PRODUCT CHANGE NOTICE

PCN#21-002

MODEL(S) AFFECTED:TCD, TCM, TCP (*see attached for a list of affected models*)**EXTENT OF CHANGE:**

Change of plastic substrate

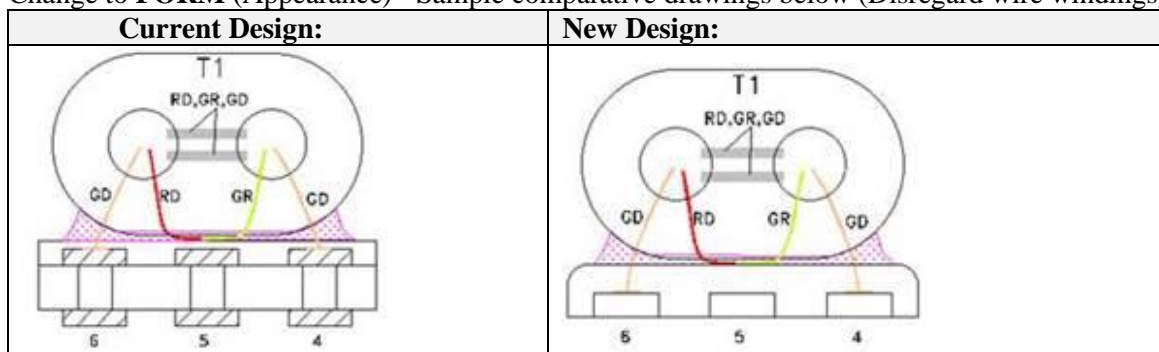
- No change to **Function** (Performance)
- Change to **FIT** (Dimension)– Drop in footprint equivalent, Reduction in total height
- Change to **FORM** (Appearance) - Sample comparative drawings below (Disregard wire windings)
